**TSG RAN Meeting #14**

**RP-010785**

**Title: CRs (R'99 and Rel-4 Category A) to TR 25.942**

**CHANGE REQUEST**

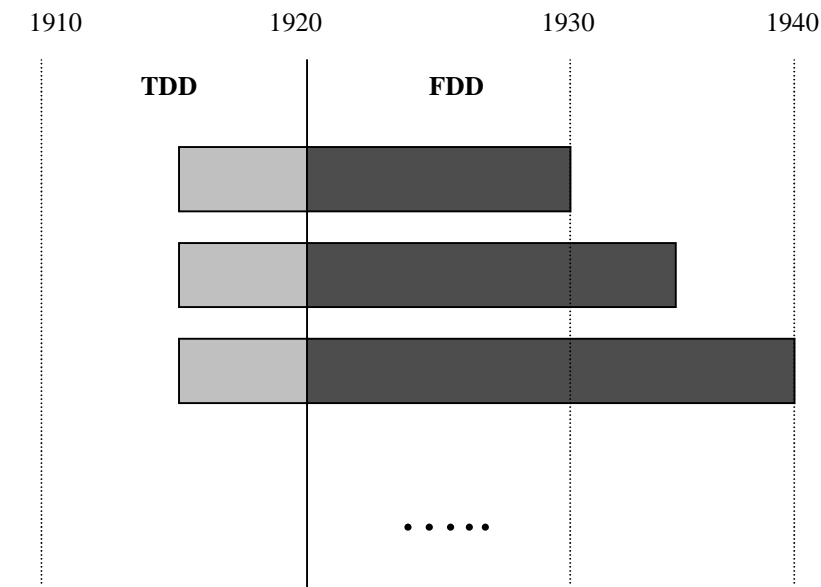
Scenario 1 in chapter 8.4.4.2 is describing the situation when UTRA-FDD and UTRA-TDD are using adjacent frequencies at 1920 MHz. For those adjacent FDD and TDD frequency bands co-location with 30dB is not possible. However, those adjacent FDD and TDD frequencies can still be used in the network given the stated minimum BS-BS coupling loss is ensured.

Co-location site solutions for the non-adjacent FDD and TDD frequency bands are described in Scenario 2a and Scenario 2b.

The filter attenuation that is proposed in the following chapters 8.4.4.3 and 8.4.4.4 are examples based on the requirements of TS 25.104 regarding blocking and accepted performance degradation.

### 8.4.3 Scenario 2a: TDD 1900-1915 MHz and FDD 1920-1940 MHz

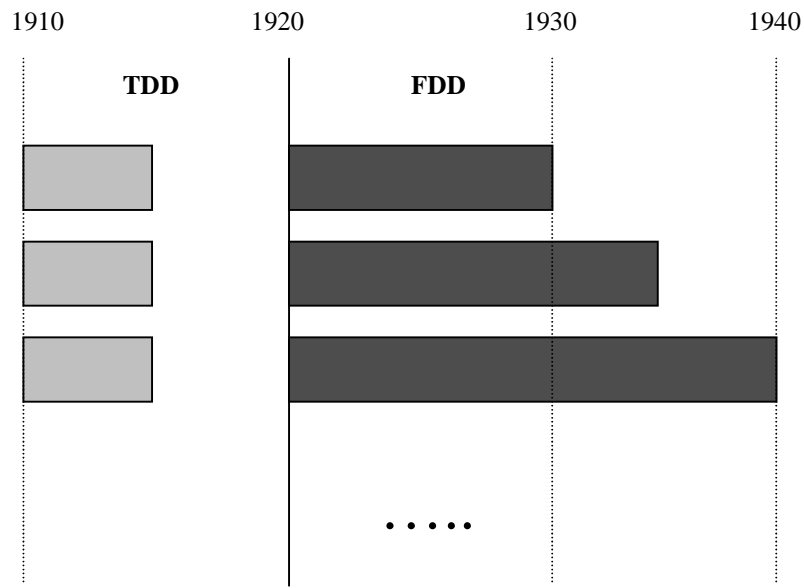
- TDD range: 1900 – 1915 MHz; TDD BS output power: +43dBm
- FDD range: 1920 – 1940 MHz

Co-location of UTRA-FDD and UTRA-TDD with 30dB BS-BS coupling loss is possible by adding an external filter in the UTRA-FDD UL chains.

• Filter parameters:

Filter attenuation requirement in the range 1900 – 1915 MHz should be at least:

$$+43\text{dBm} + 3\text{dB [Multicarrier margin]} - 30\text{dB [BS-BS coupling loss]} - (-40\text{dBm [FDD inband blocking]}) = 56\text{dB}$$

Inband losses of the filter in the range 1920 – 1940MHz: < 1dB

### 8.4.4 Scenario 2b: TDD 1900-1920 MHz and FDD 1930-1980 MHz

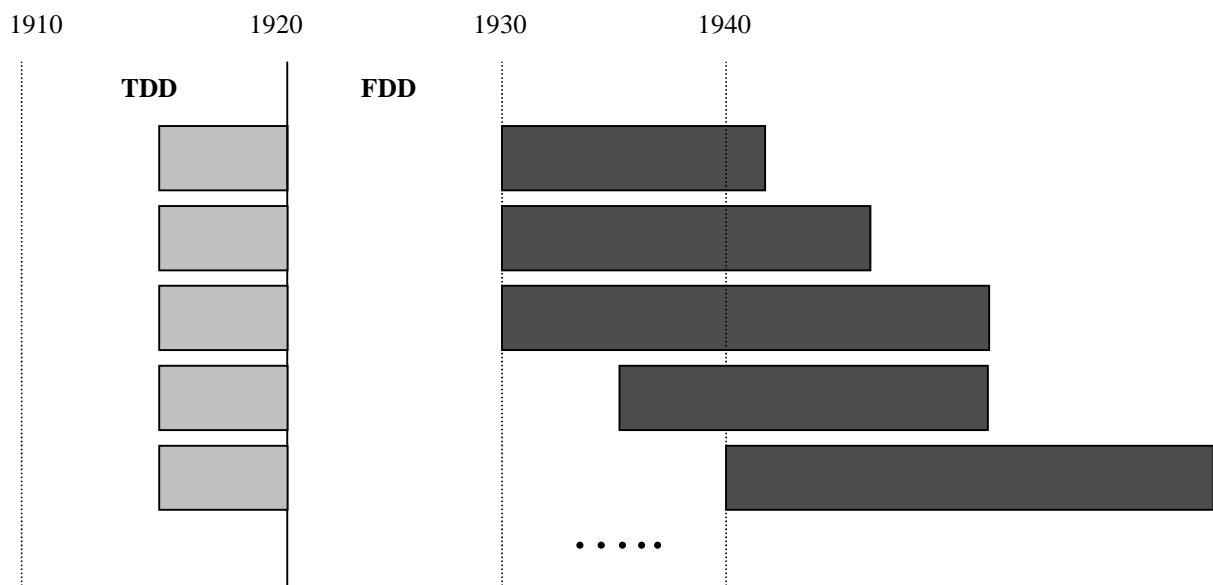
- TDD range: 1900 – 1920 MHz; TDD BS output power: +43dBm
- FDD range: 1930 – 1980 MHz

Co-location of UTRA-FDD and UTRA-TDD with 30dB BS-BS coupling loss is possible by adding an external filter in the UTRA-FDD UL chains.

• Filter parameters:

Filter attenuation requirement in the range 1900 – 1920 MHz should be at least:

$$+43\text{dBm} + 3\text{dB [Multicarrier margin]} - 30\text{dB [BS-BS coupling loss]} - (-40\text{dBm [FDD inband blocking]}) = 56\text{dB}$$

Inband losses of the filter in the range 1930 – 1980 MHz: < 1dB

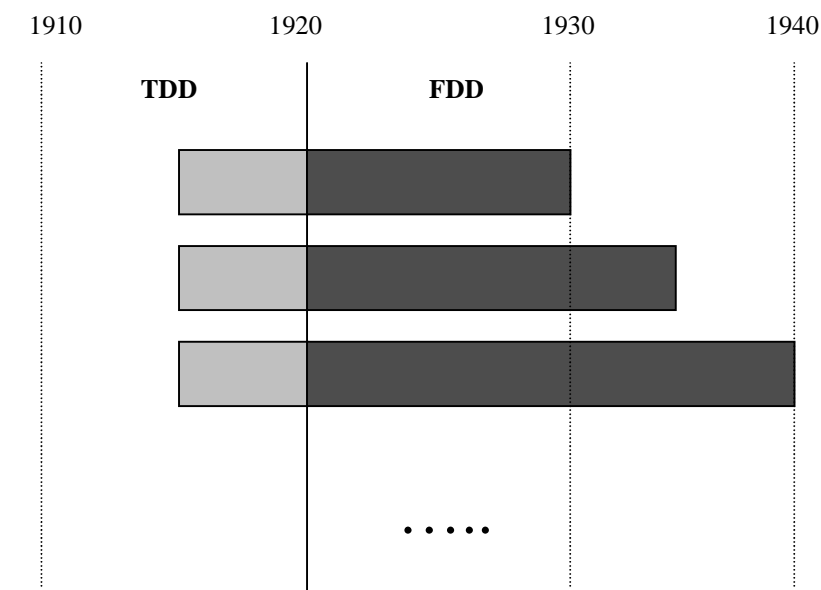
Scenario 1 in chapter 8.4.4.2 is describing the situation when UTRA-FDD and UTRA-TDD are using adjacent frequencies at 1920 MHz. For those adjacent FDD and TDD frequency bands co-location with 30dB is not possible. However, those adjacent FDD and TDD frequencies can still be used in the network given the stated minimum BS-BS coupling loss is ensured.

Co-location site solutions for the non-adjacent FDD and TDD frequency bands are described in Scenario 2a and Scenario 2b.

The filter attenuation that is proposed in the following chapters 8.4.4.3 and 8.4.4.4 are examples based on the requirements of TS 25.104 regarding blocking and accepted performance degradation.

### 8.4.3 Scenario 2a: TDD 1900-1915 MHz and FDD 1920-1940 MHz

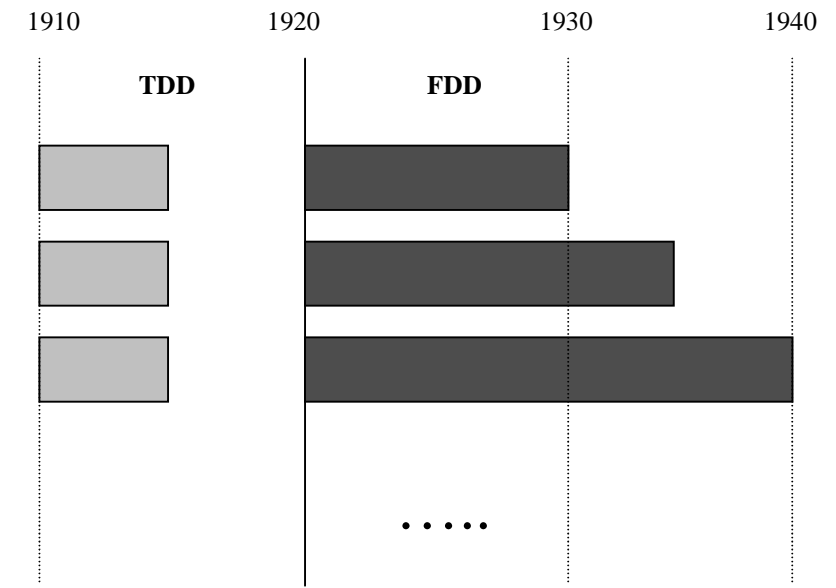
- TDD range: 1900 – 1915 MHz; TDD BS output power: +43dBm
- FDD range: 1920 – 1940 MHz

Co-location of UTRA-FDD and UTRA-TDD with 30dB BS-BS coupling loss is possible by adding an external filter in the UTRA-FDD UL chains.

• Filter parameters:

Filter attenuation requirement in the range 1900 – 1915 MHz should be at least:

$$+43\text{dBm} + 3\text{dB [Multicarrier margin]} - 30\text{dB [BS-BS coupling loss]} - (-40\text{dBm [FDD inband blocking]}) = 56\text{dB}$$

Inband losses of the filter in the range 1920 – 1940MHz: < 1dB

**8.4.4 Scenario 2b: TDD 1900-1920 MHz and FDD 1930-1980 MHz**

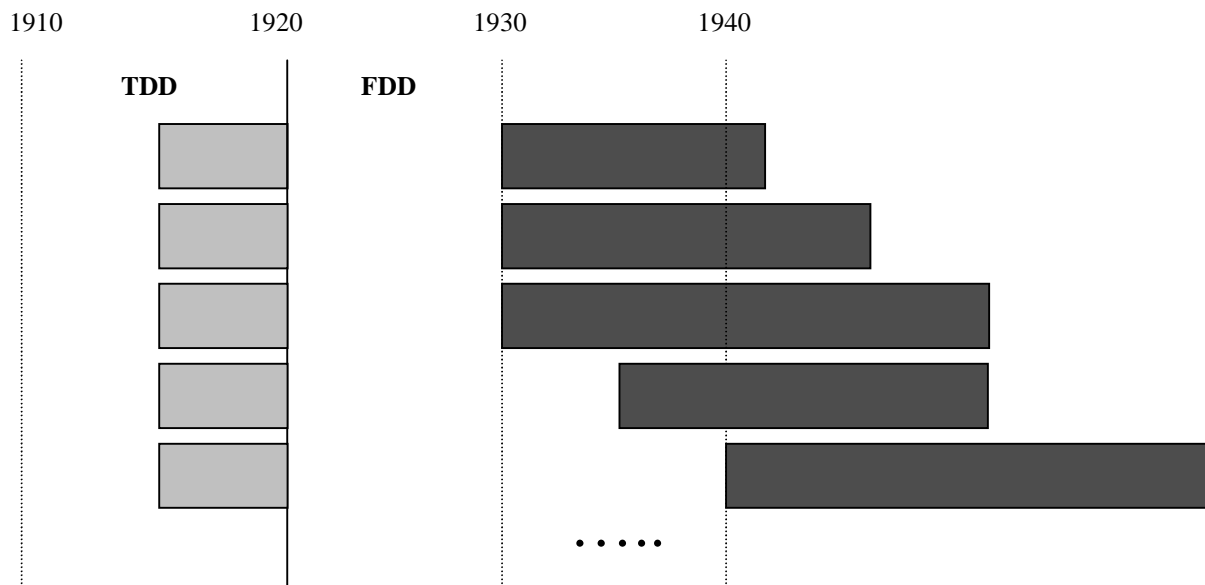
- TDD range: 1900 – 1920 MHz; TDD BS output power: +43dBm
- FDD range: 1930 – 1980 MHz

Co-location of UTRA-FDD and UTRA-TDD with 30dB BS-BS coupling loss is possible by adding an external filter in the UTRA-FDD UL chains.

• Filter parameters:

Filter attenuation requirement in the range 1900 – 1920 MHz should be at least:

$$+43\text{dBm} + 3\text{dB [Multicarrier margin]} - 30\text{dB [BS-BS coupling loss]} - (-40\text{dBm [FDD inband blocking]}) = 56\text{dB}$$

Inband losses of the filter in the range 1930 – 1980 MHz: < 1dB
